Determination 2014/024

Regarding the issue of a notice to fix for building work carried out to remove a retaining wall at 107 Wharf Street, Tauranga

2.3 The original wall

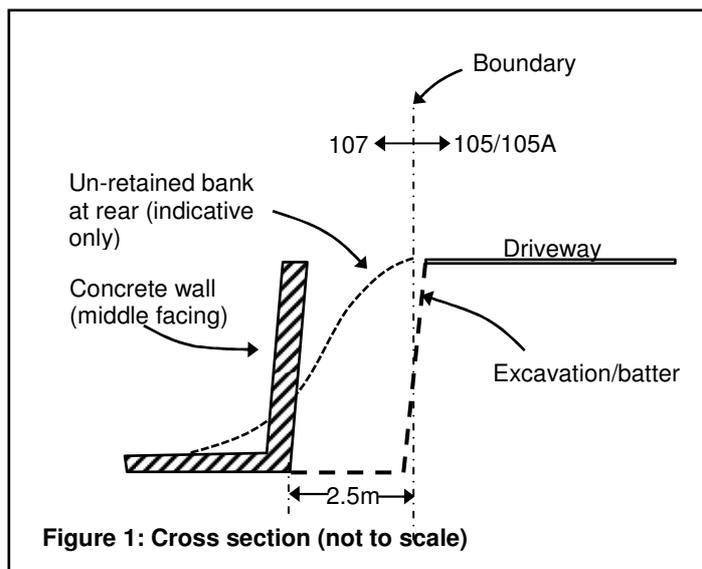
- 2.3.1 The applicant has stated that the original wall was made up of ‘free-standing concrete panels’, that it was ‘not attached at the bottom, had no reinforcing, and was not attached at the top’.
- 2.3.2 Photographs provided by the applicant, dated 11 March 2008, appear to show a concrete block wall with a concrete walkway running atop the wall, with concrete steps leading down at the north end and established trees and planting adjacent to the walkway. At the top of the wall and running along the edge of the pathway there was a metal barrier with wire netting.
- 2.3.3 A large portion of the original wall was made up of a number of tilted concrete slabs, and a smaller section (at the stairs) was cast in situ. The wall was located approximately 2.5m from the common boundary and within the applicant’s property.
